RotorSport UK Ltd Service Bulletin (CofA)

Title: Cavalon pro fuel tank/body seal		
SB-C-004 Iss1	Related documents Modification: MC-357 CCAR No.: CCAR-063	Compliance Category: OPTIONAL or RECOMMENDED or MANDATORY
Applicability		
Aircraft type & model: Cavalon Pro	Aircraft serial Nos. affected: RSUK/CVLN/011 RSUK/CAVP/001 RSUK/CAVP/002	
The maintenance manual to be referenced is this stated or subsequent issue.		RSUK0335 Iss2
This form is the response from RotorSport UK Ltd either against a problem found in the product in service requiring a containment or rectification action, or as service information for aircraft modification incorporation. For help, contact RotorSport on 44(0)1588 505060, or email compliance@rotorsport.org . The technical content of this document is approved under the authority of the UK CAA Design Organisation Approval Ref: DAI/9917/06

AG-SB-2016-06-B-EN – Cavalon fuel-tank inlay ring

Fig. 1: Fuel filler

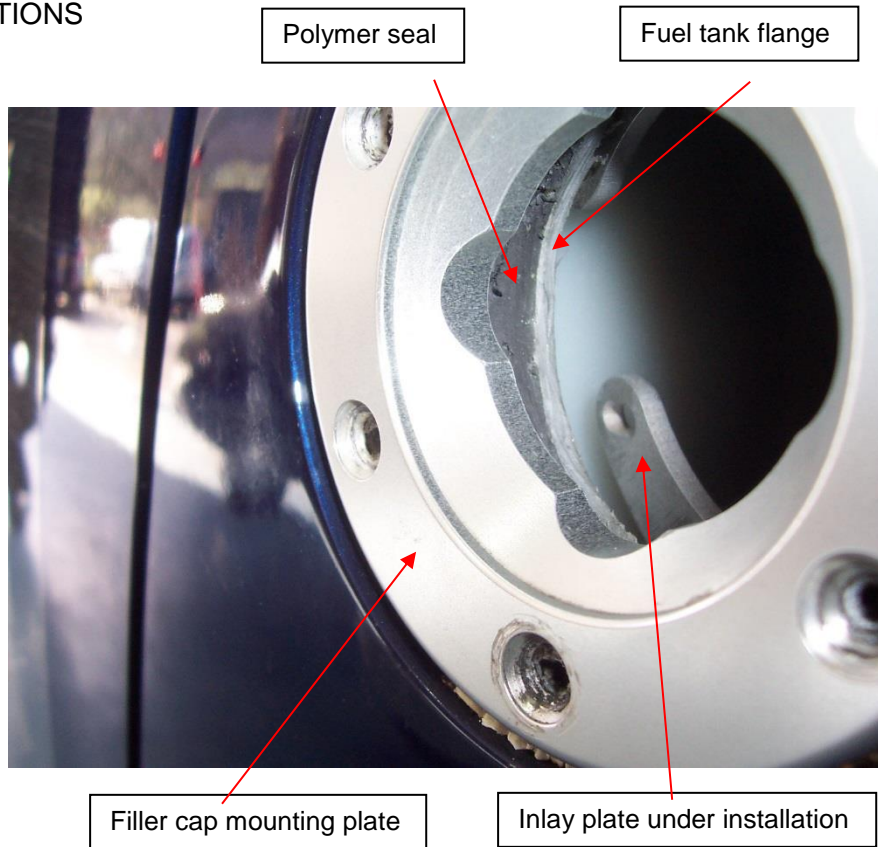
At the affected Cavalon an aluminium “inlay ring” is placed inside the filler neck and by means of a new rubber seal combined with longer fuel filler mounting screws allows the fuel tank flange to be pulled uniformly against the body – squeezing the new rubber seal between to ensure a perfect sealing (see fig. 1).
